**PARK CITY BOARD OF ADJUSTMENT MEETING
SUMMIT COUNTY, UTAH
May 21, 2024**

6.A. **341 Ontario Avenue – Appeal** – The Applicant Appeals the Planning Director's Denial of a Historic District Design Review Modification for the Relocation of a Hot Tub and New Stairs in the Side Setback on a Significant Historic Site and Steep Slope in the Historic Residential-1 Zoning District. PL-24-06091
(A) Public Hearing; (B) Action

Subject: 341 Ontario Avenue
Application: PL-24-06091
Author: Lillian Zollinger, Planner II
Date: May 21, 2024
Type of Item: Appeal of Historic District Design Review Modification Denial

2021 Approved HDDR Design

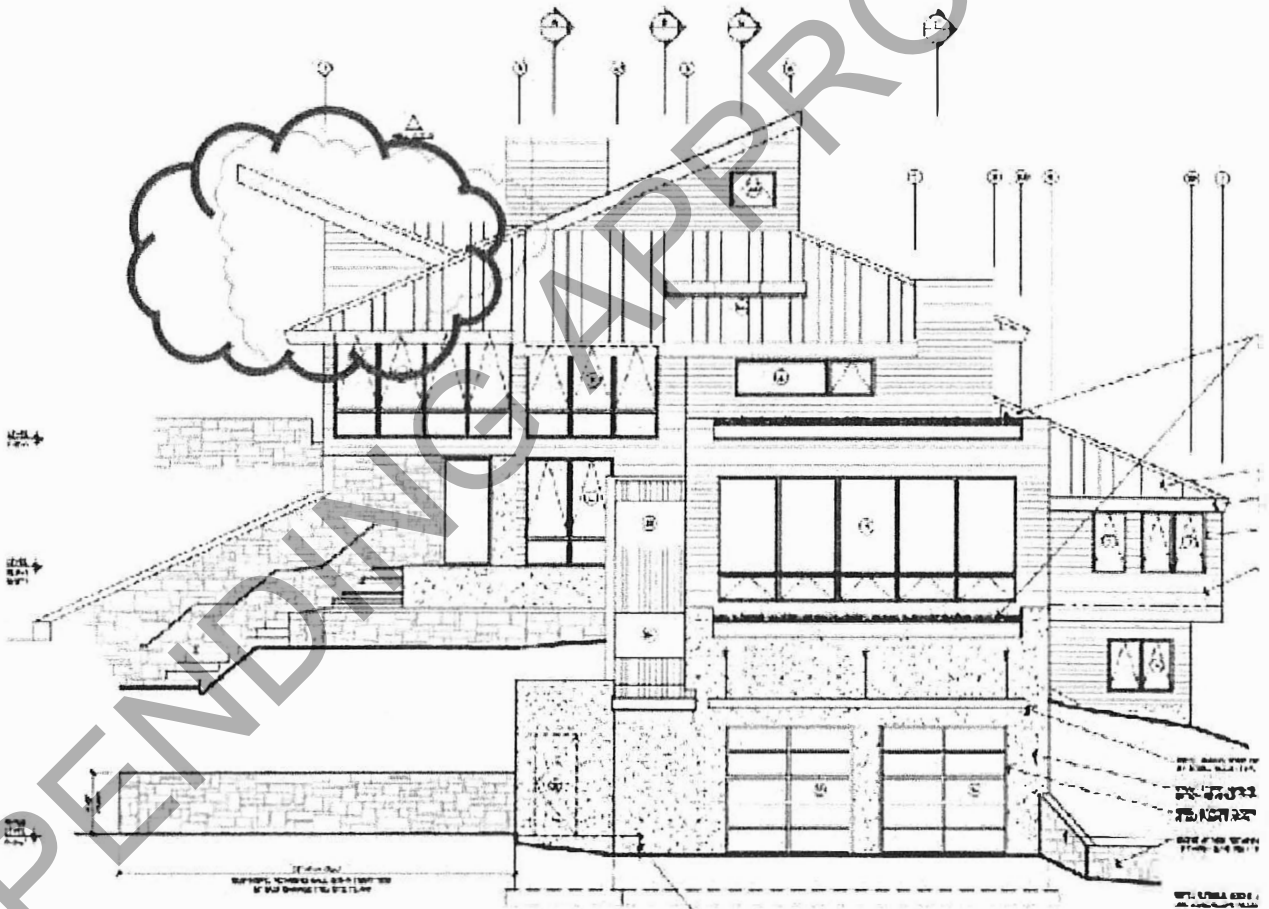
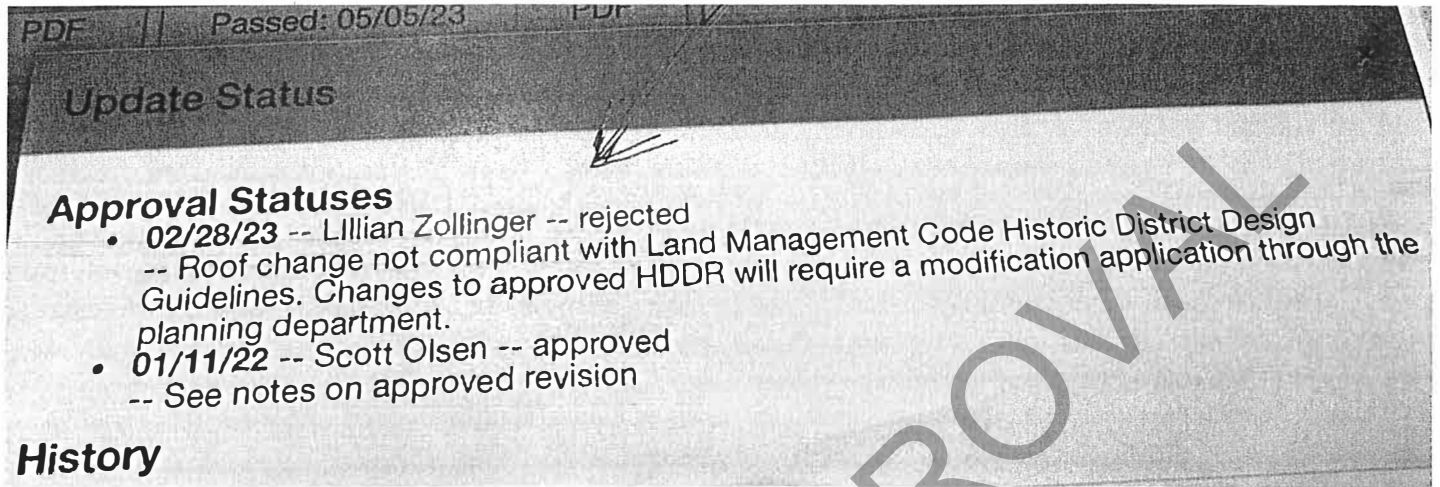
Between December 21, 2021 and January 11, 2022 – Roof change submitted to the City for review/approval.

Revision approval for scope clouded and noted as details 1 dated 12/22/21 only.

Proposed modification bubbled red

February 28, 2023 – The Planning team rejected the modification to Building Permit 21-1271 (thirteen months later).

7. On February 28, 2023, the Planning team rejected the modification to Building Permit 21-1271 finding the proposed inverted shed roof was beyond the scope of the HDDR approval and was incompatible with the Historic District regulations.

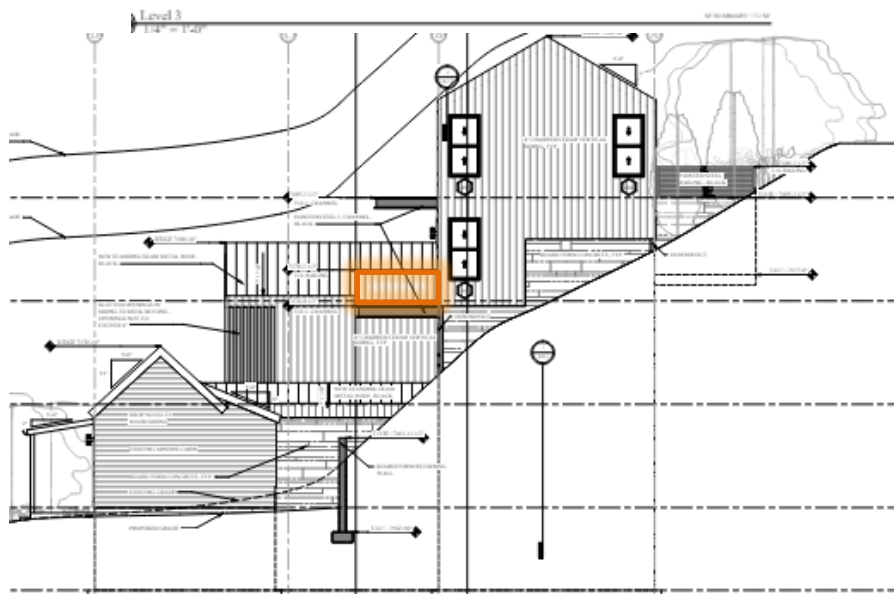
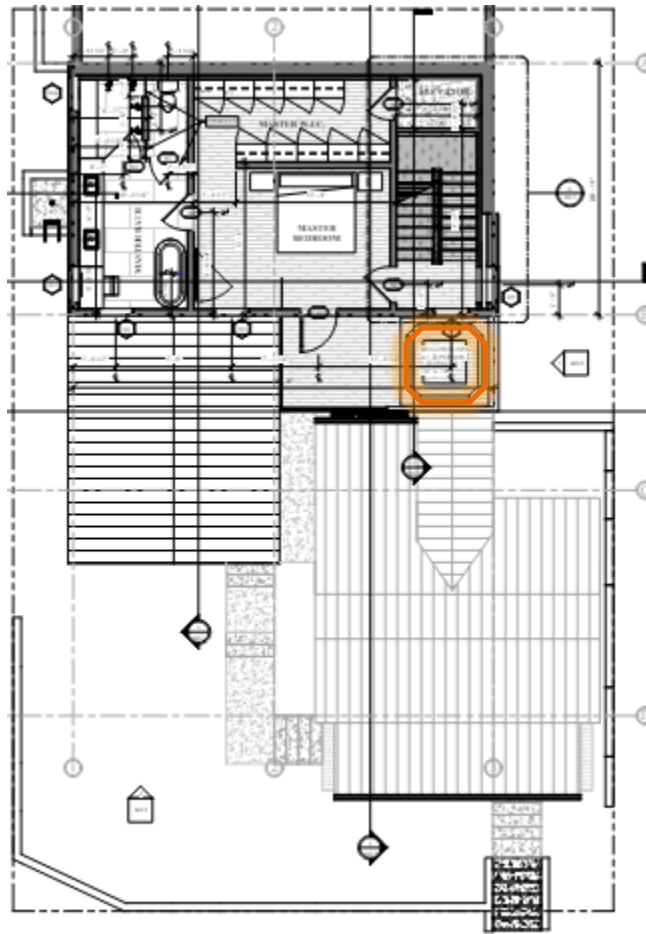
Departments. The plans attached to the permit included a screened hot tub on the third level rear deck, as placed and proposed by the Applicant, and all three departments approved the location (highlighted in orange).

The Applicant originally placed the hot tub in a location that would not further disturb the Very Steep Slope. Now, the Applicant notes that the original and approved location of the hot tub is not safe. However the approved hot tub location was selected and designed by the Applicant's professionals, and the Building Permit plans were signed and stamped by licensed professionals. The City also reviewed the original hot tub location and approved the building permit in compliance with applicable building code and engineering standards, as represented by the application submittal. Appellant submits no evidence to the contrary.

2 STAIR & FINAL GRADE
1/4" = 1'-0"

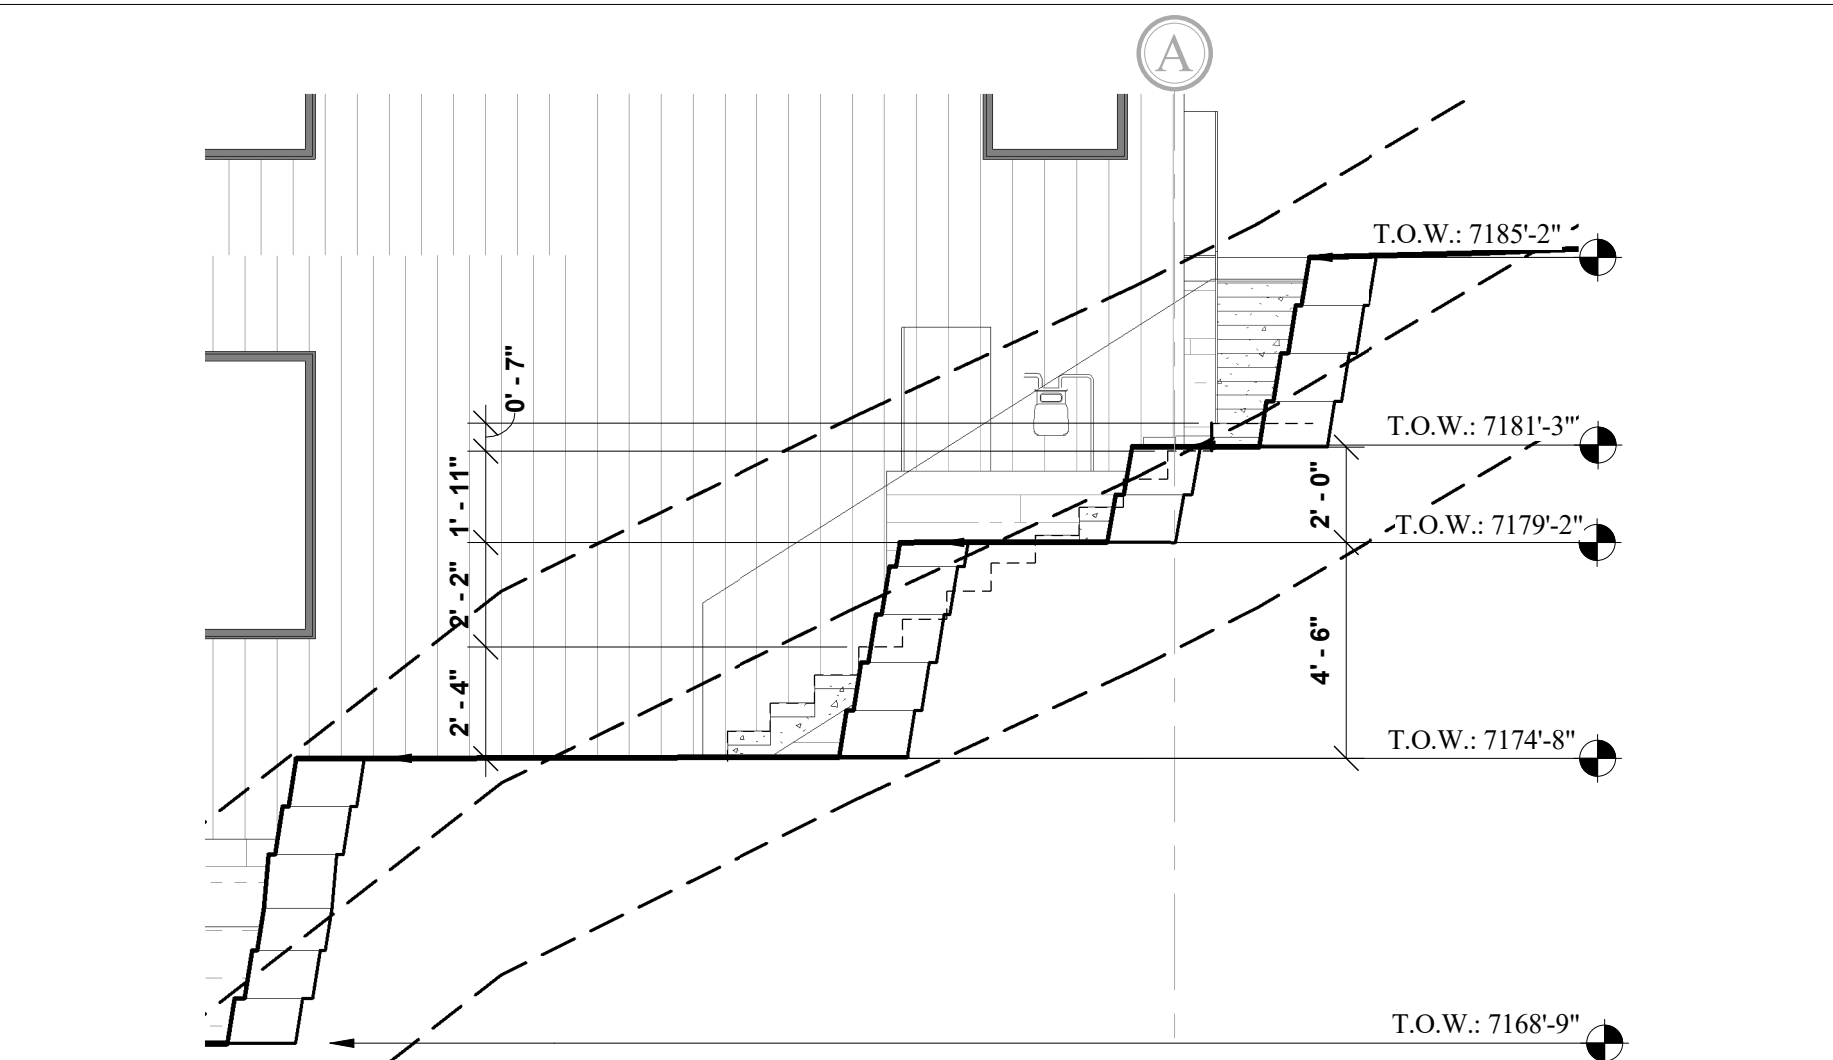
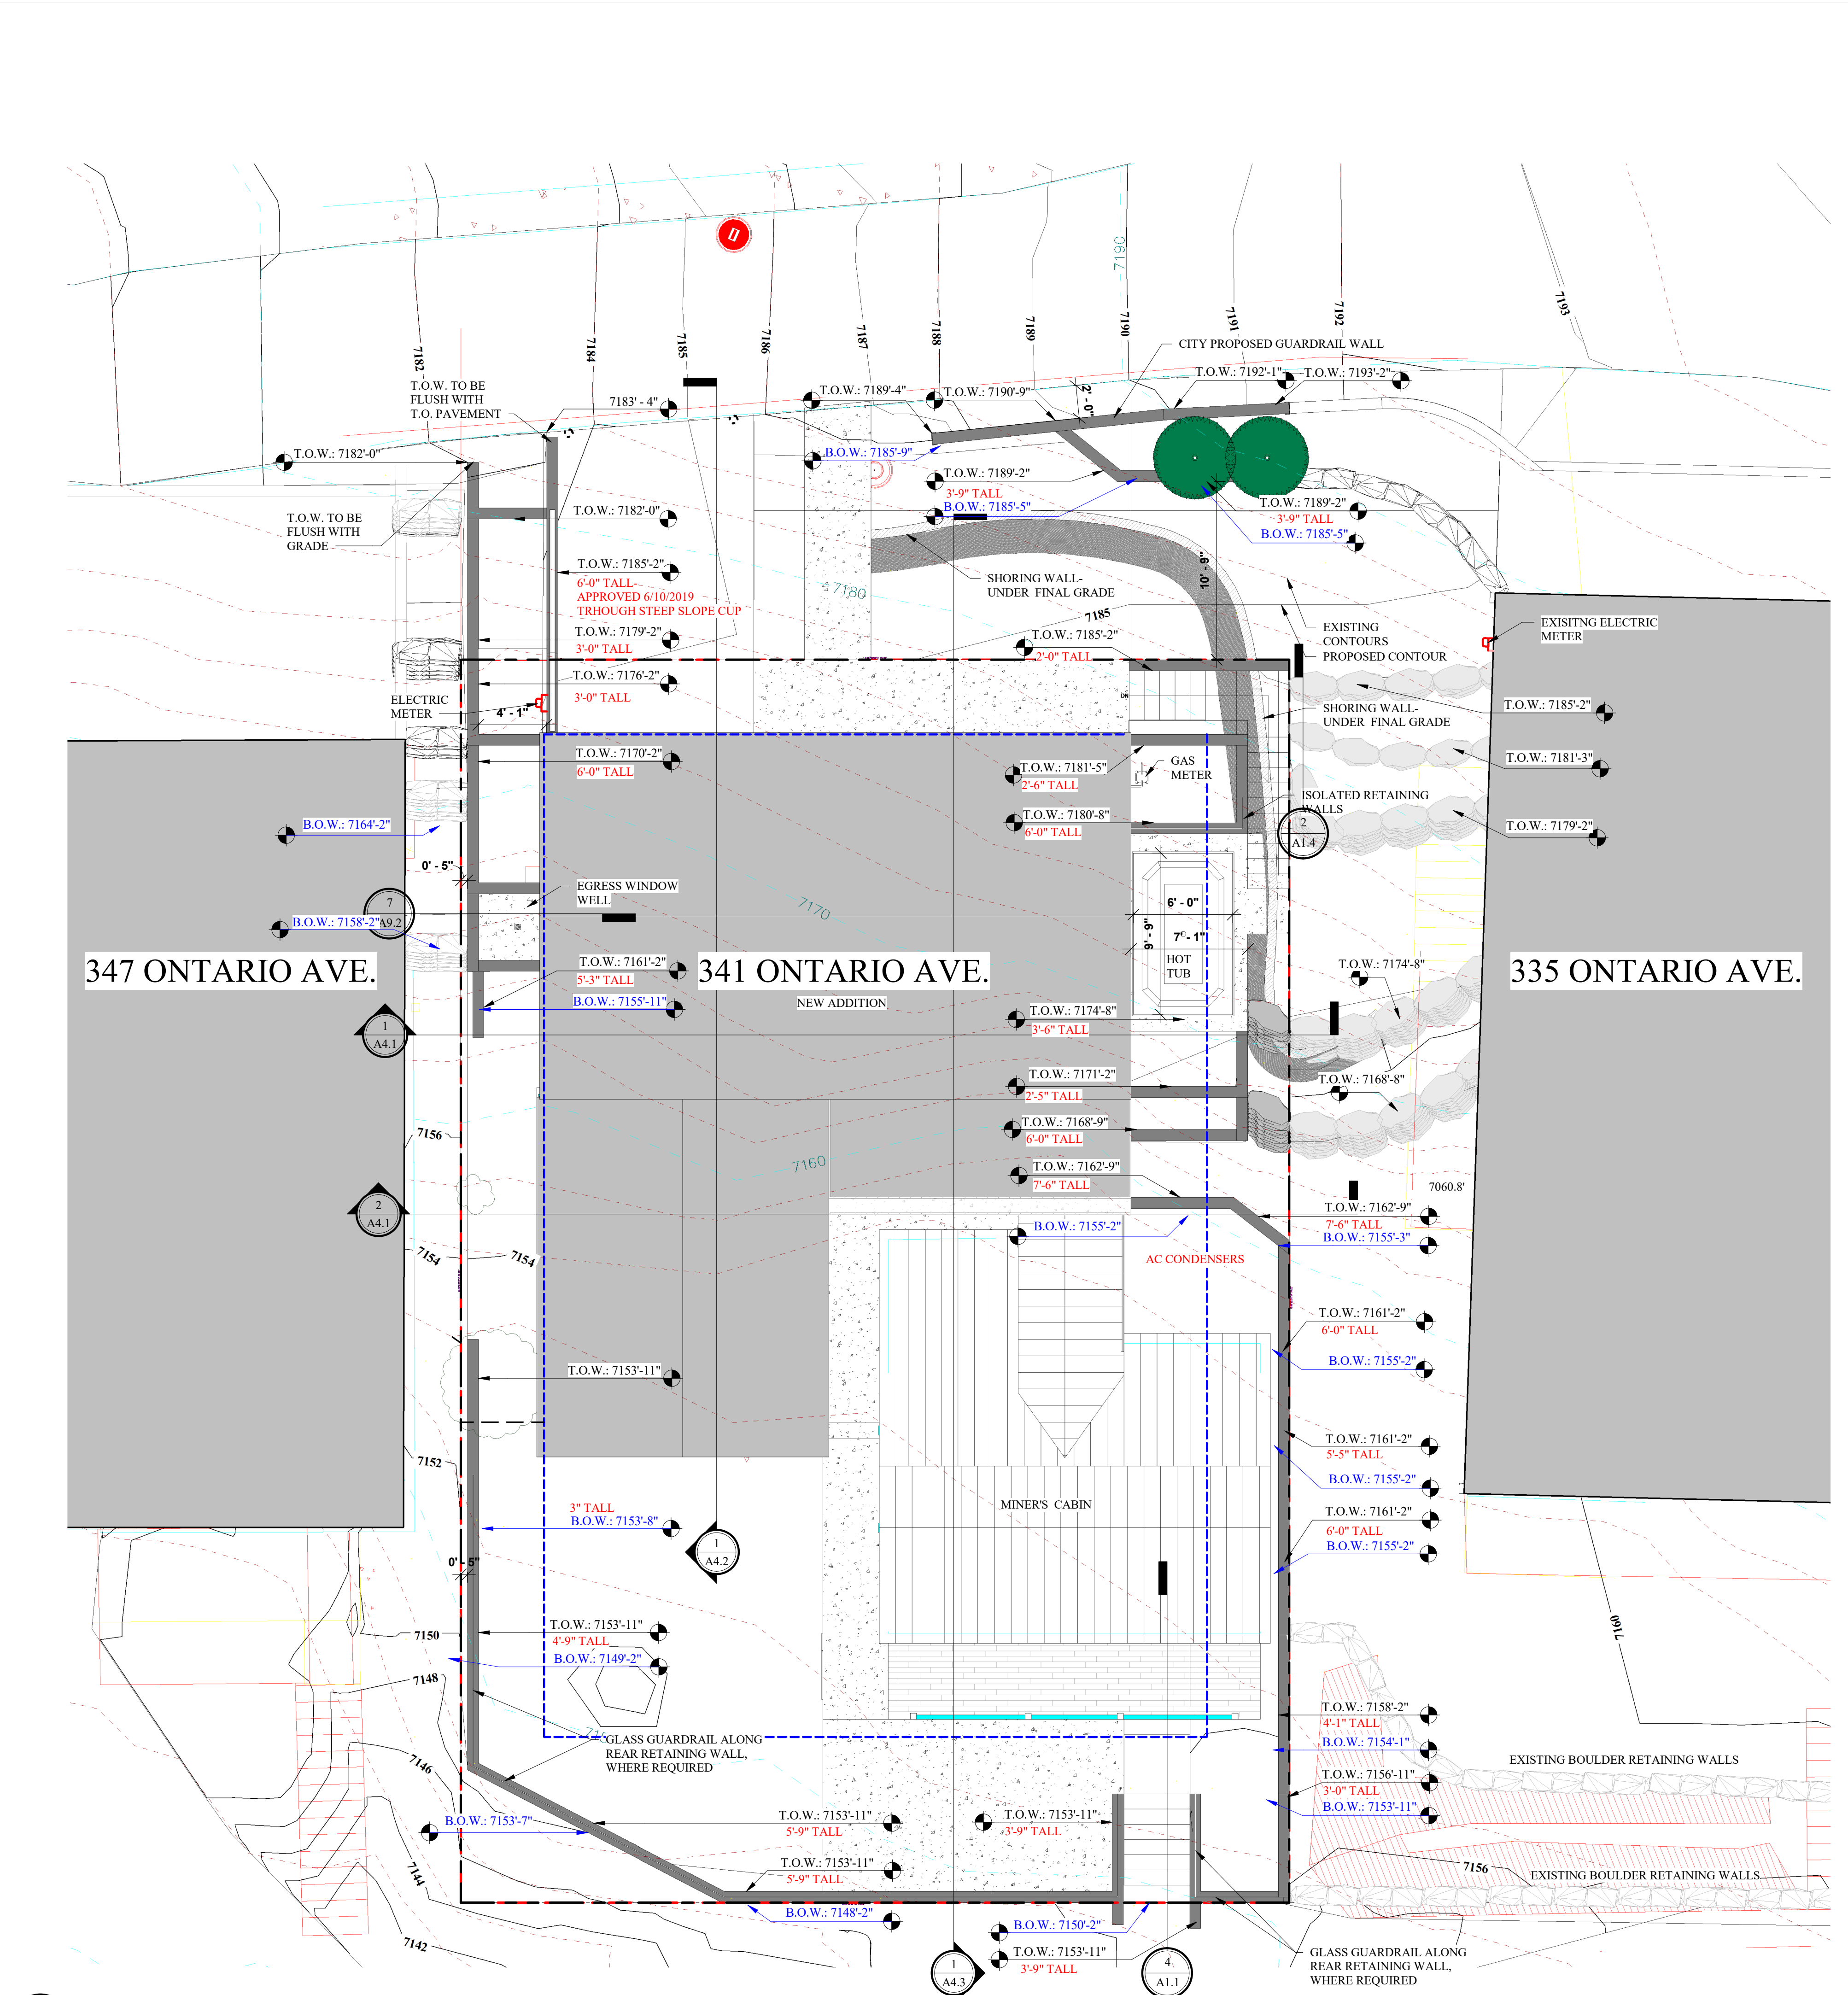
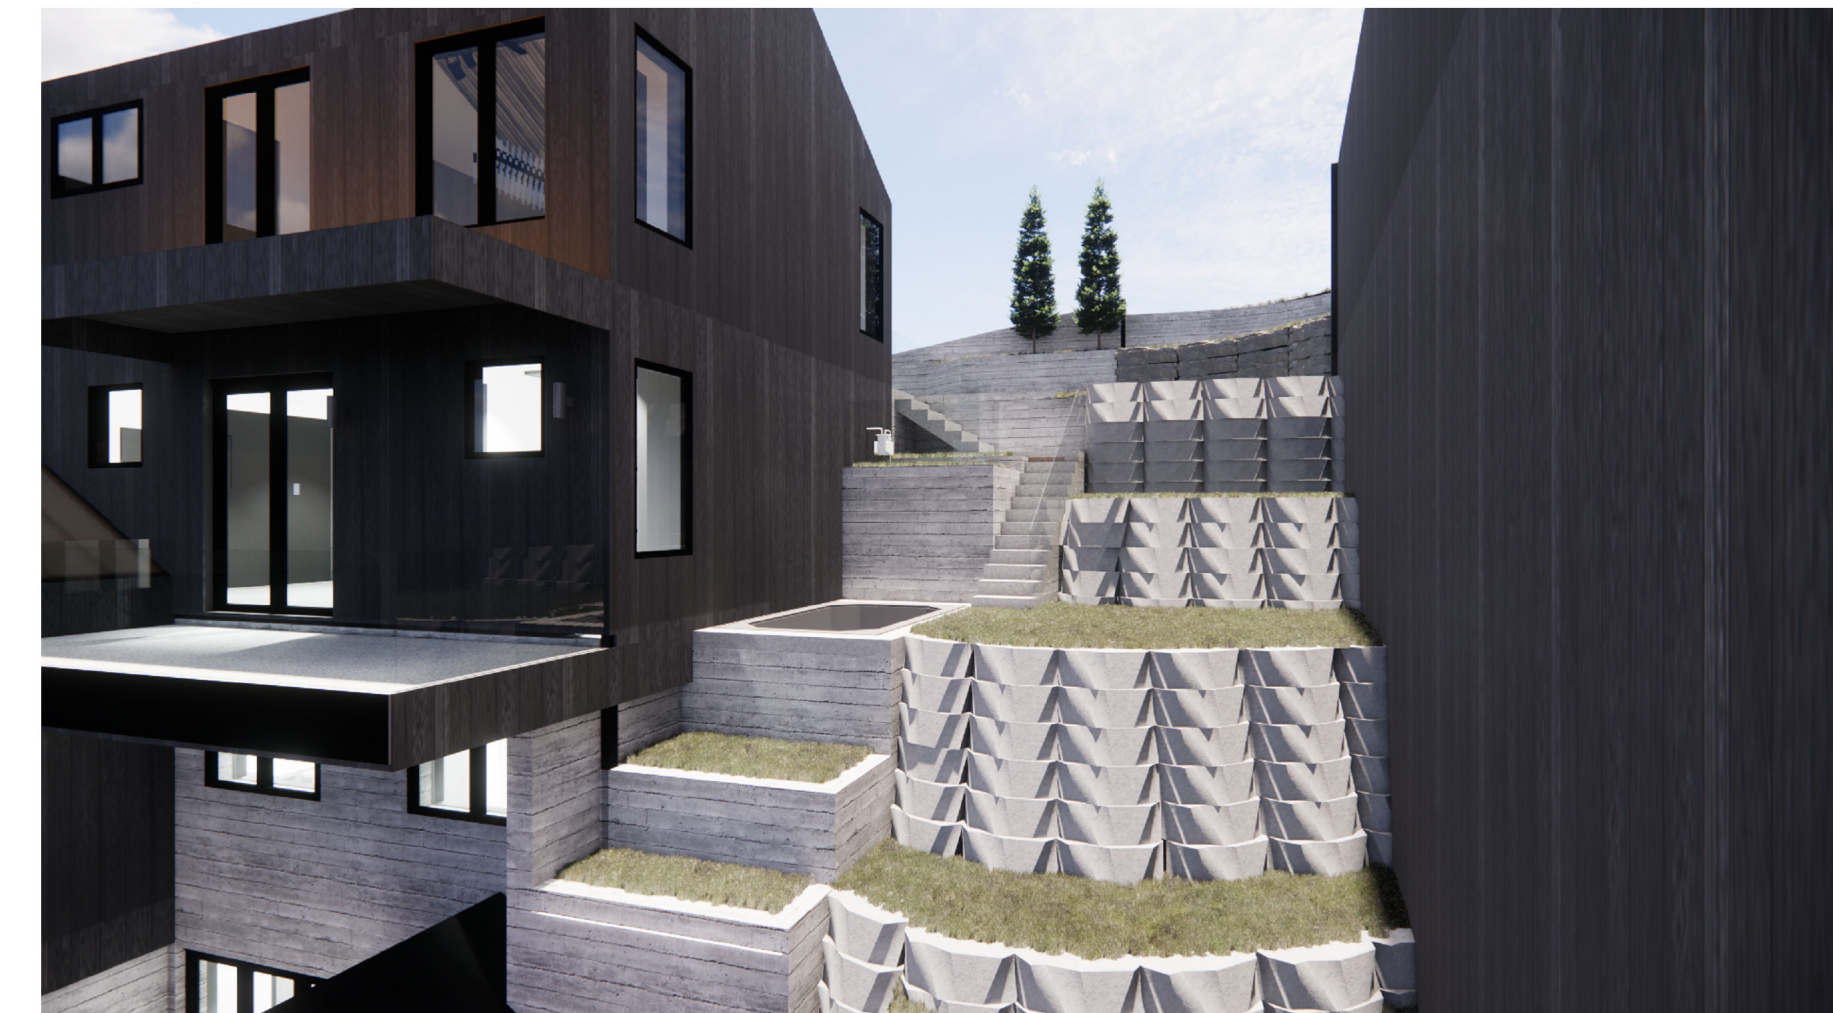
15. On March 29, 2024, the Planning Director denied the HDDR Modification, finding the following:
 1. "Land Management Code (LMC) § 15-2.2-5 outlines height requirements for the Historic Residential – 1 Zoning District and states final grade must be within four vertical feet of existing grade, except for window wells, emergency egress, and a garage entrance. The hot tub is not a window well, emergency egress, or garage entrance and is proposed to be sunken into grade by five feet, eight inches disturbing existing grade by five feet, eight inches and therefore does not comply.

2. LMC § 15-2.2-6 outlines requirements for development on Steep Slopes within the Historic Residential – 1 Zoning District and states, "[d]evelopment on Steep Slopes must be environmentally sensitive to hillside Areas, carefully planned to mitigate adverse effects on neighboring land and Improvements, and consistent with the Design Guidelines for

As determined by the Planning Director, LMC [§ 15-13-2\(B\)\(1\)\(b\)\(1\)](#), LMC [§ 15-13-2\(B\)\(1\)\(b\)\(2\)](#), and past approvals, the Applicant is required to return the site to as close to existing grade as possible. The proposed in-ground hot tub and stairs on a Very Steep Slope further impact the final grade of the historic site and do not bring the grade into closer compliance with existing grade.
